DOCUMENT 00 90 00
ADDENDUM

ADDENDUM NO. [3] Date: March 5, 2019

**RE: WESTERN TECHNICAL COLLEGE
ARC & WELCOME CENTER REMODELING PHASE 2
400 SEVENTH STREET NORTH
LA CROSSE, WISCONSIN 54601
HSR PROJECT NO. 18047**

**FROM: HSR Associates, Inc
100 Milwaukee Street
La Crosse, WI 54603
(608) 784-1830**

A090R2

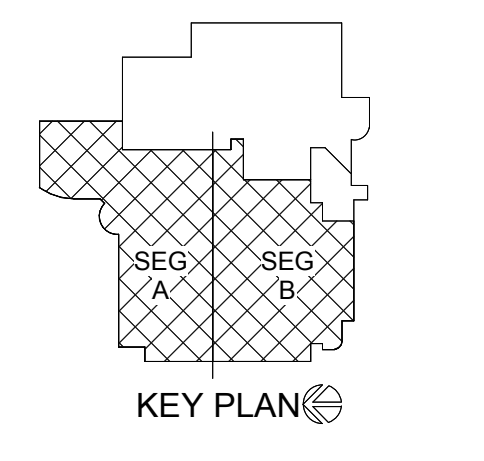
1. Sheet A000R1 COVER SHEET 30 x 42 attached hereto
 - a. Revisions clouded on Drawing.
2. Sheet A090R2 FIRST FLOOR REMOVAL PLAN 30 x 42 attached hereto
 - a. Revisions clouded on Drawing.

A100R2

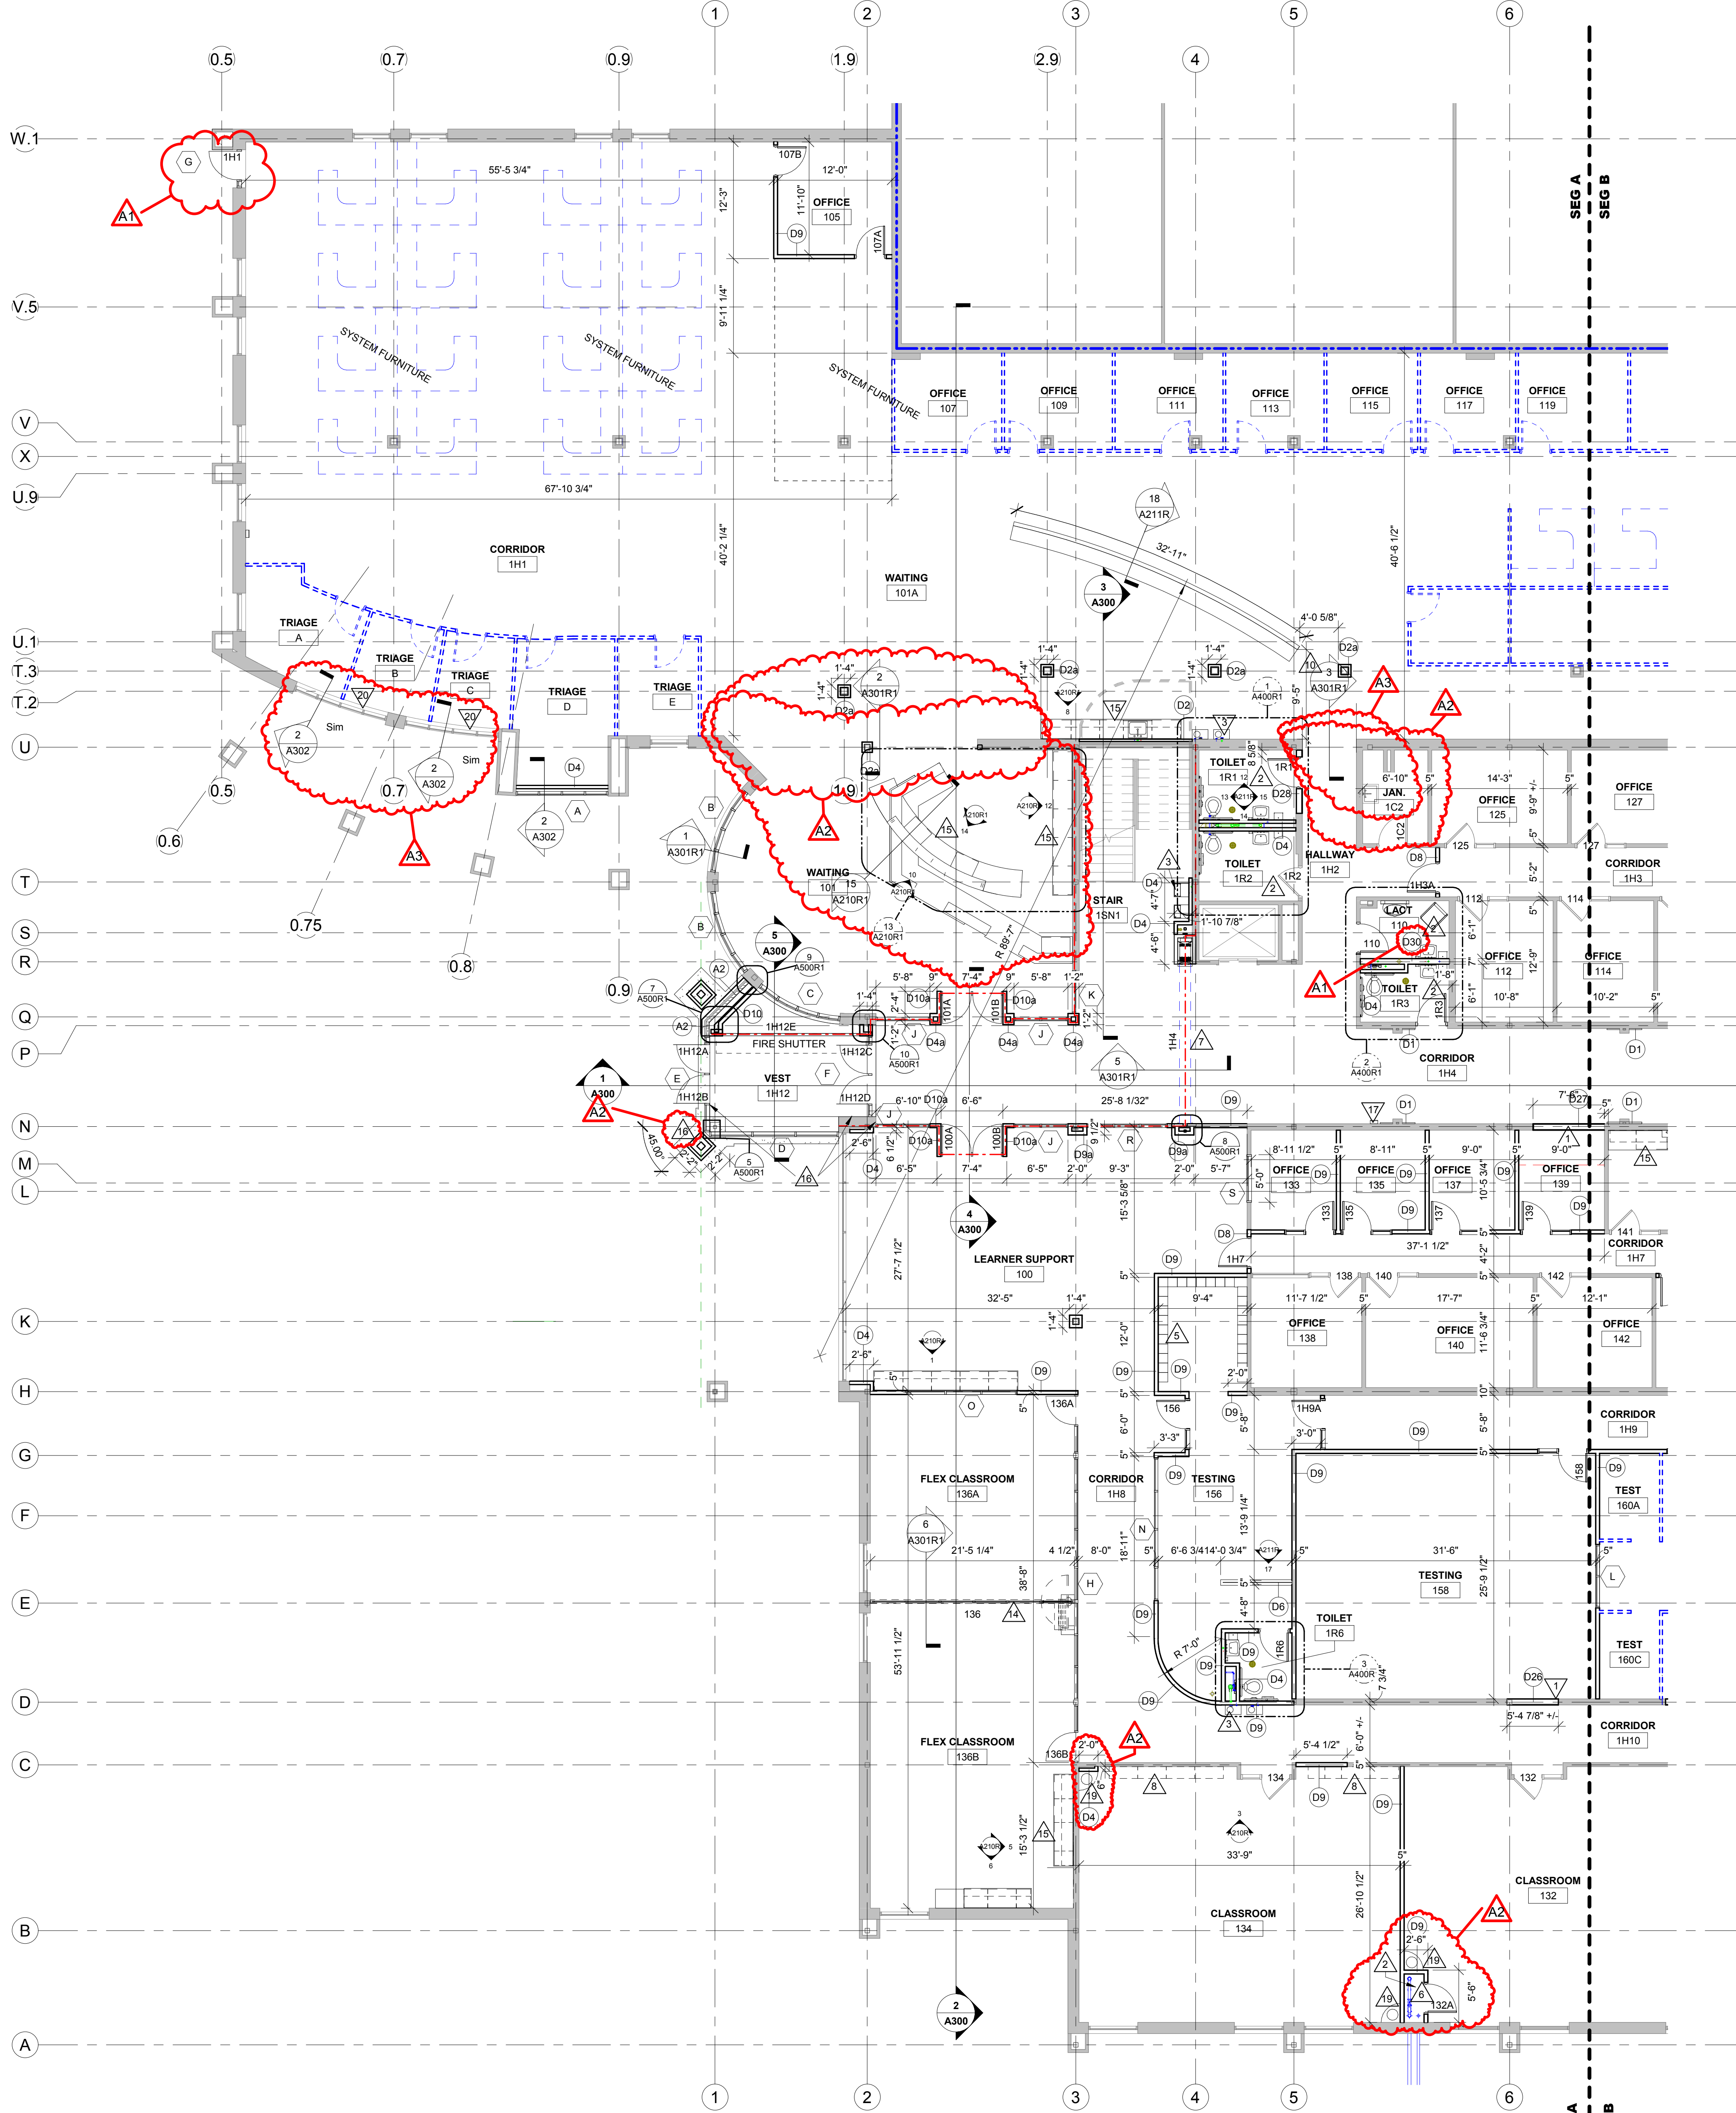
3. Sheet A100R2 FIRST FLOOR REMODELED PLAN – SEG A 30 x 42 attached hereto
 - a. Revisions clouded on Drawing.
4. Sheet ID102 FIRST FLOOR FINISH PLAN SEGMENTS A

M400R

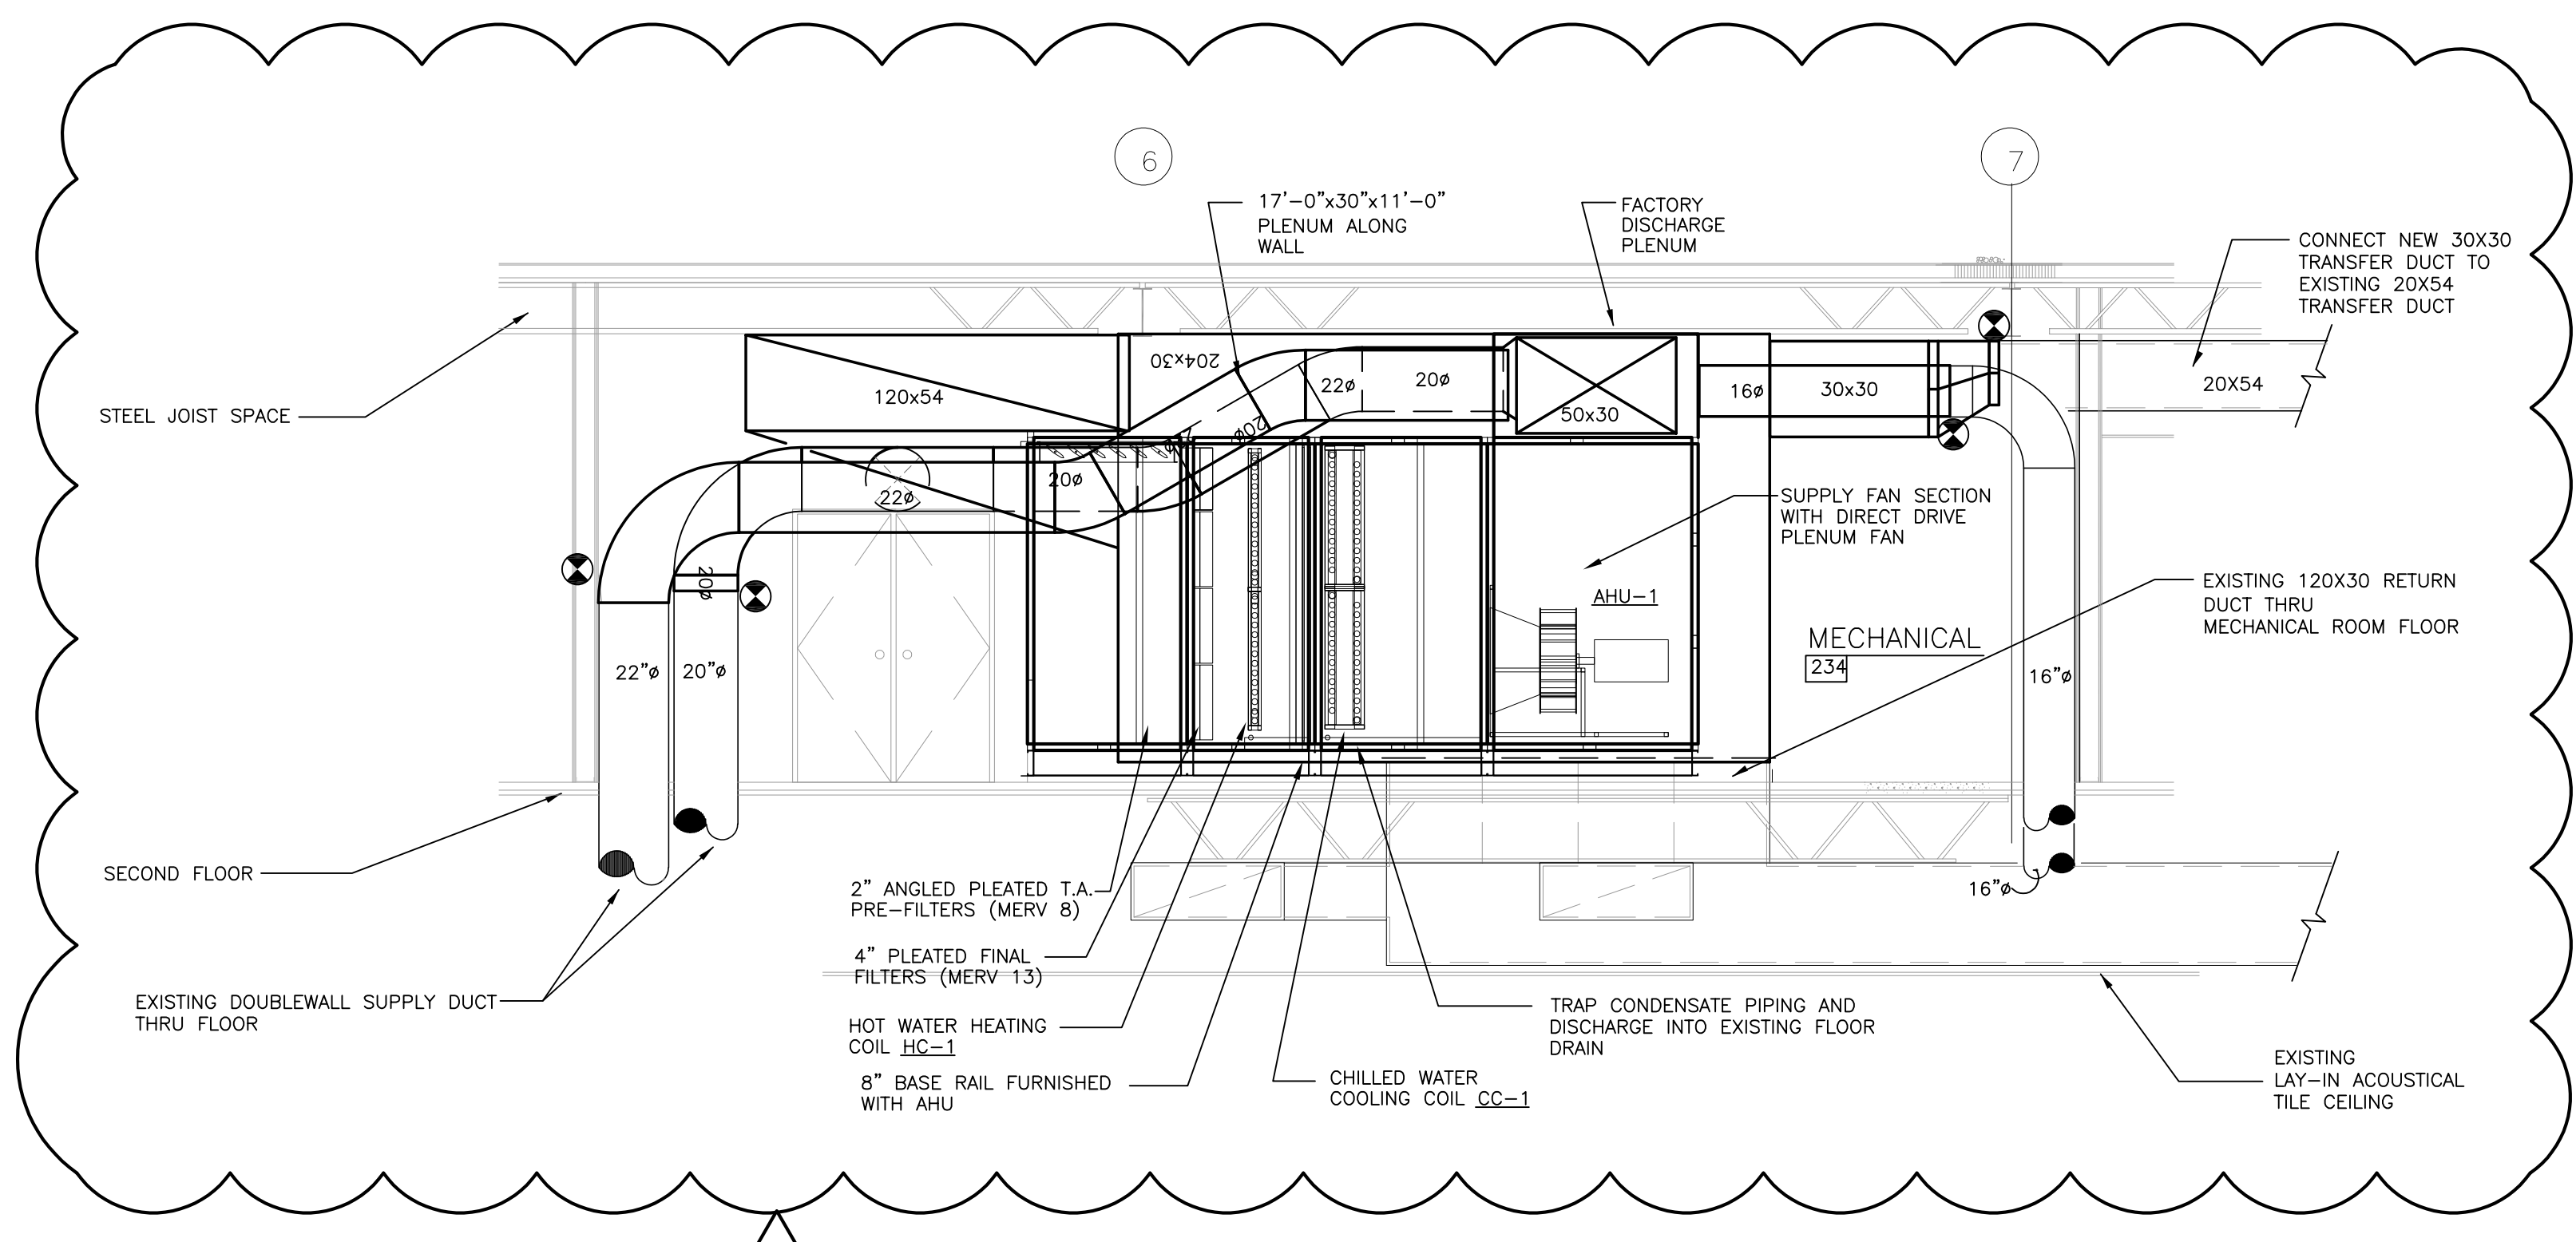
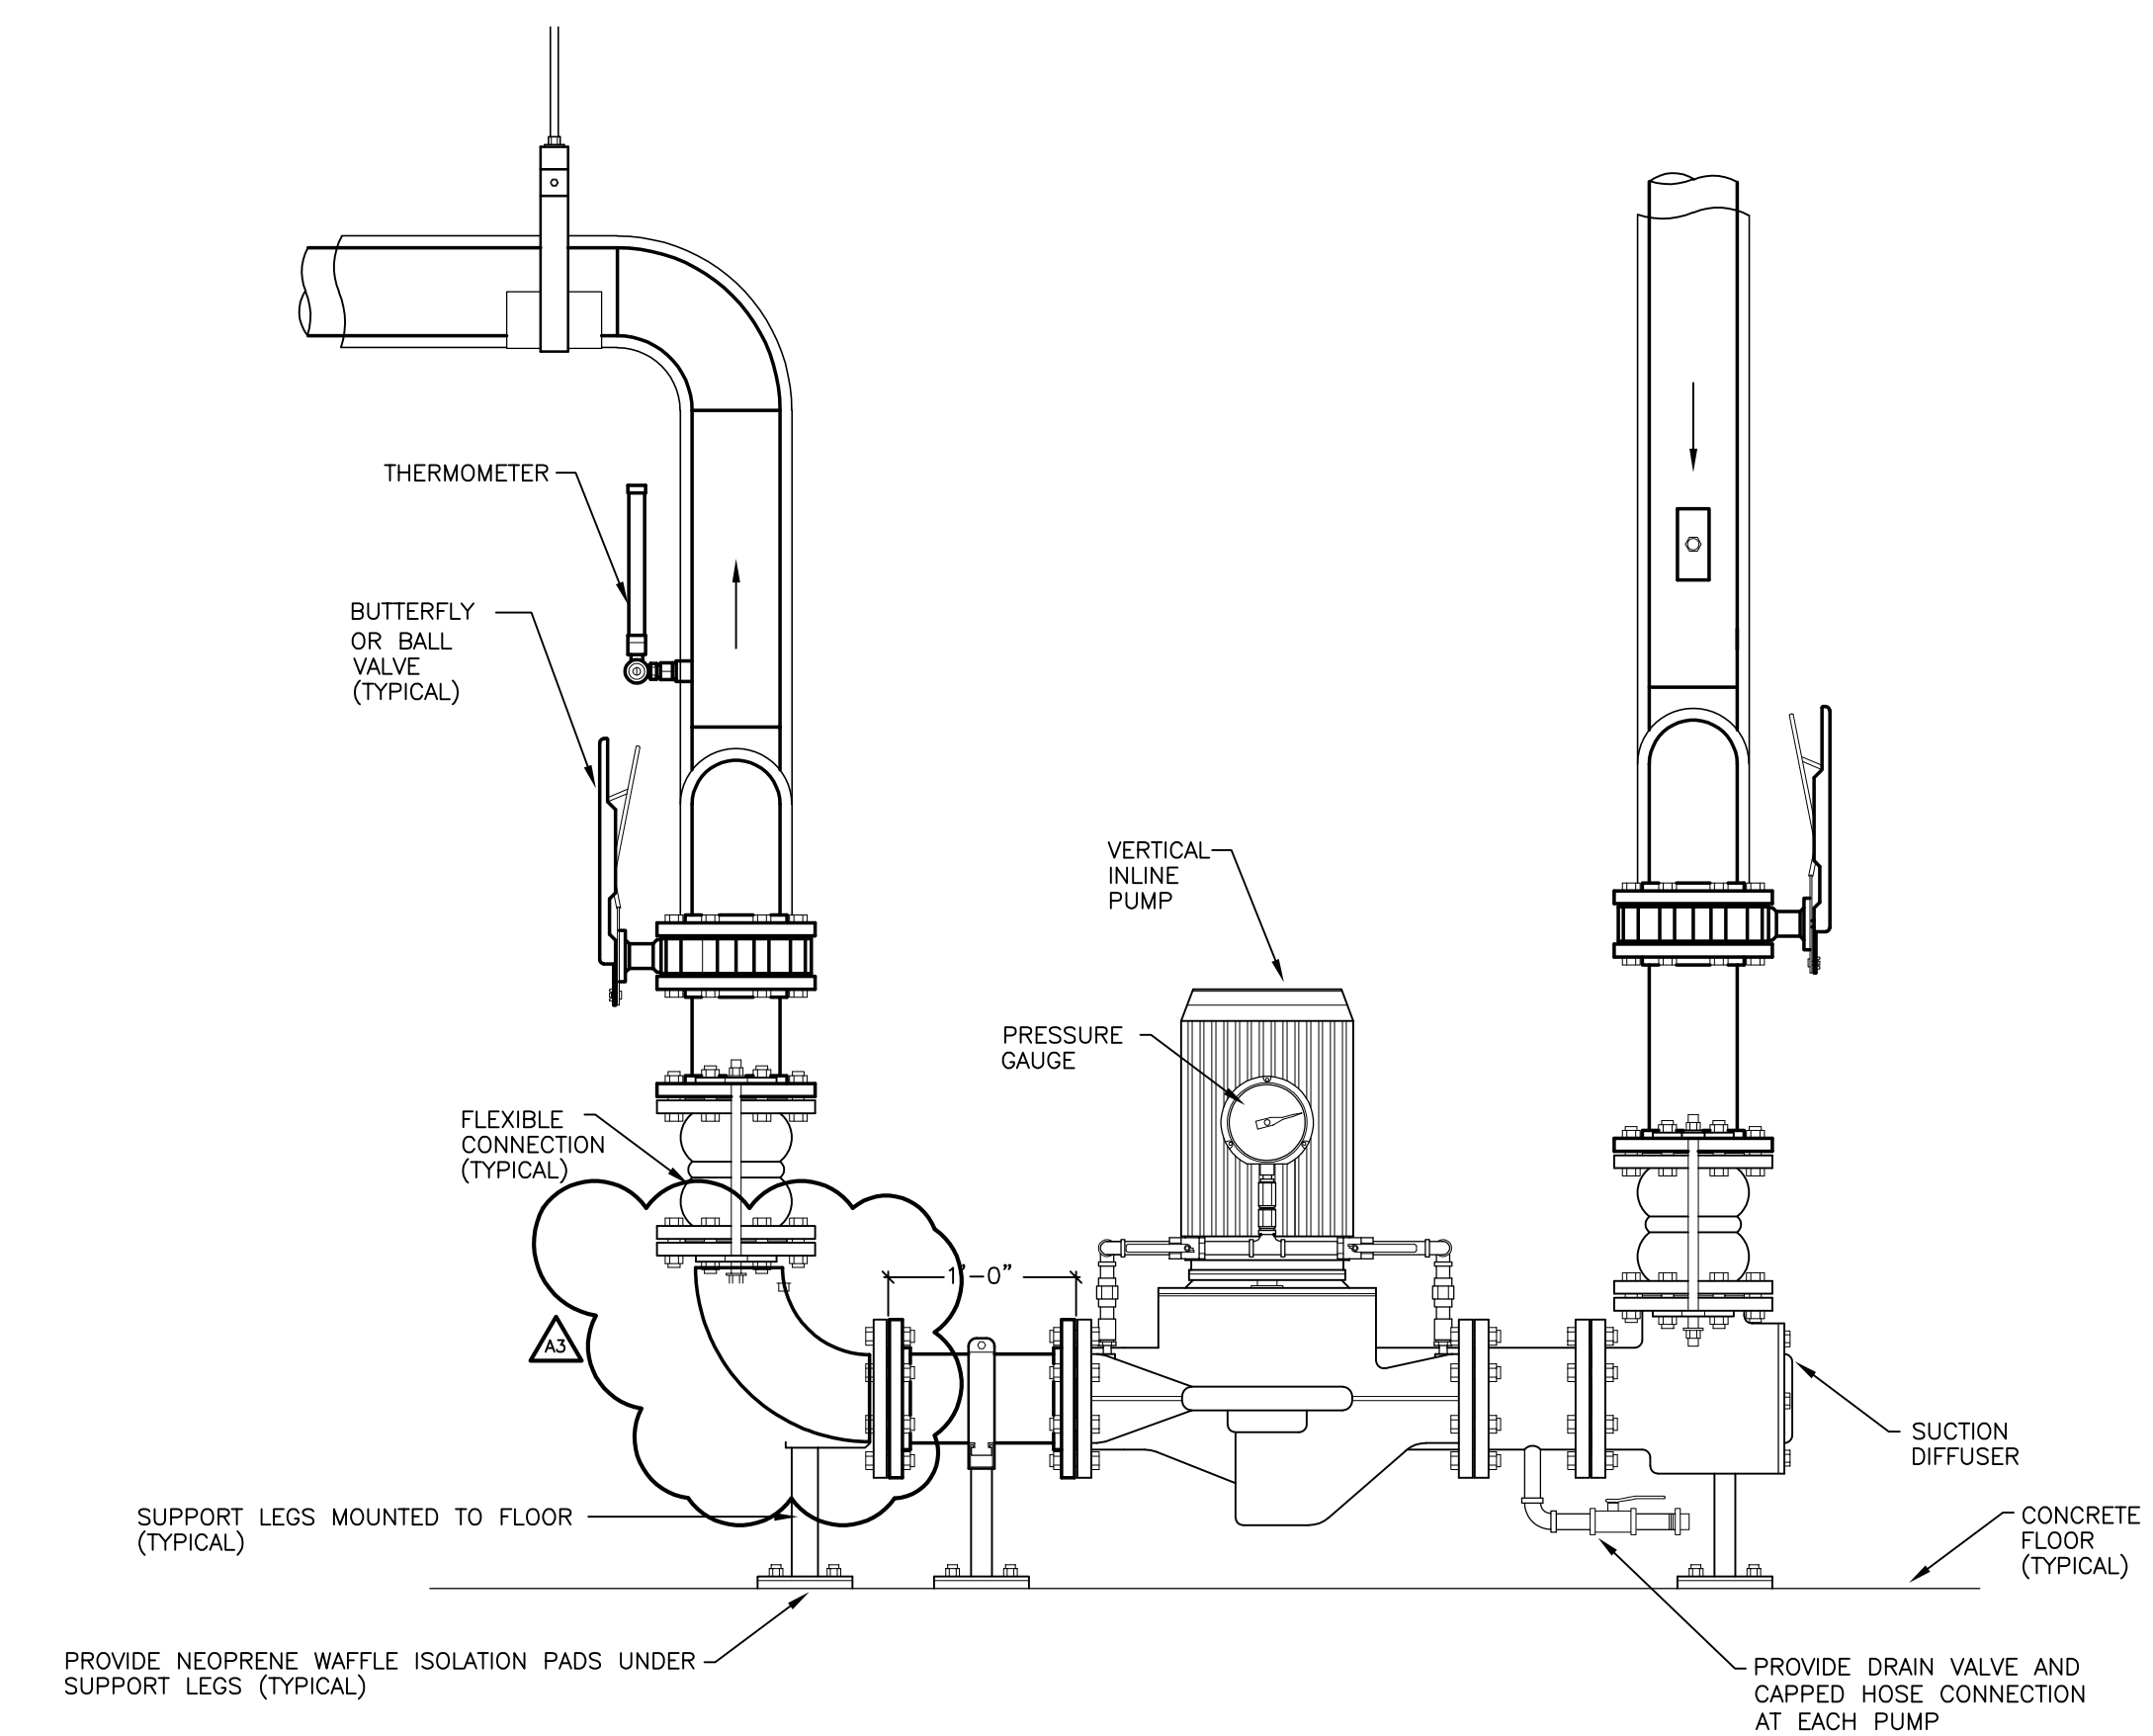
10. Sheet M400R LARGE SCALE MECHANICAL PLAN 30 x 42 attached hereto
 - a. Revisions clouded on Drawing.
11. Sheet M600R HVAC SCHEDULES 30 x 42 attached hereto
 - a. Revisions clouded on Drawing.
